## ABQ BIO-PARK INSECTARIUM

SHEET CONTENTS  
GRADING PLAN

**Re: ABQ Bio-park Insectarium  
Request for Permanent C.O. – Accepted  
Engineer's Stamp dated: 12-10-13 (J12D014A)  
Certification dated: 5-12-15**

## GRADING AND DRAINAGE PLAN

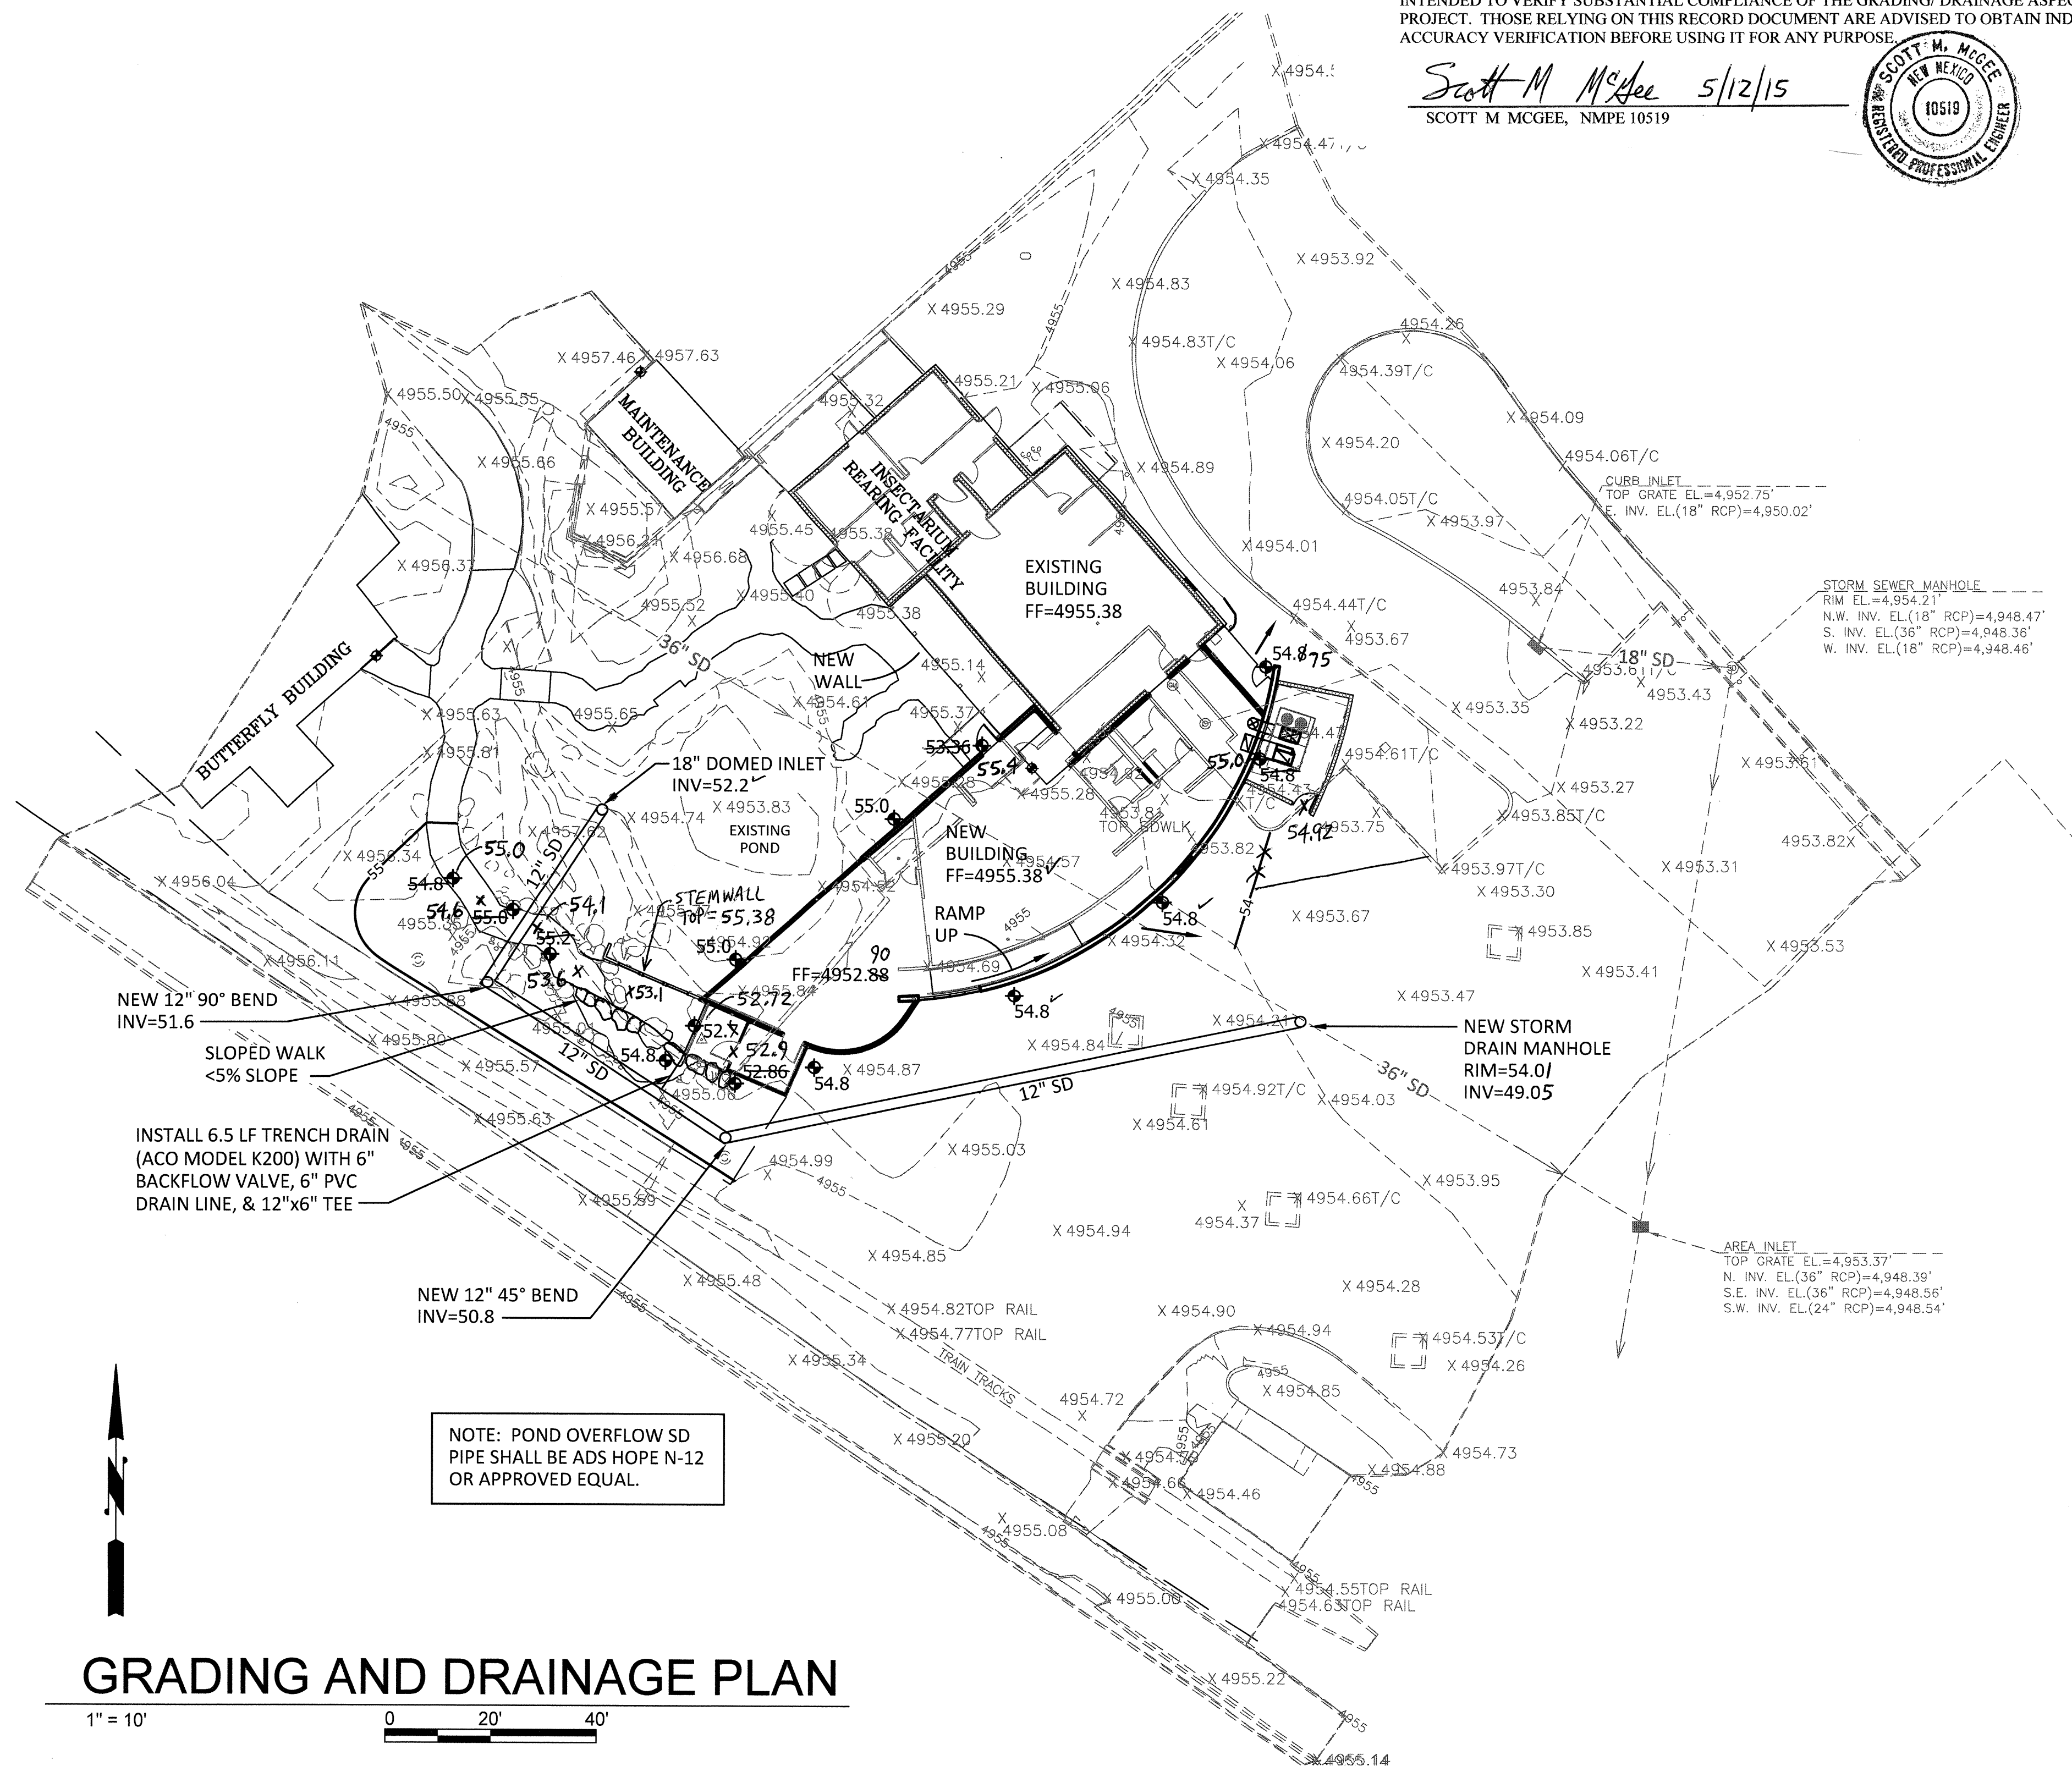
Based on the Certification received on 5/12/2015, and the letter dated 5/20/2015 from Catherine Hubbard taking responsibility for the area, the Insectarium is acceptable for release of Certificate of Occupancy by Hydrology.

The BioPark will take responsibility for addressing the pond flooding, and removing the piles of dirt and debris. TA Cole will remove their construction fence.
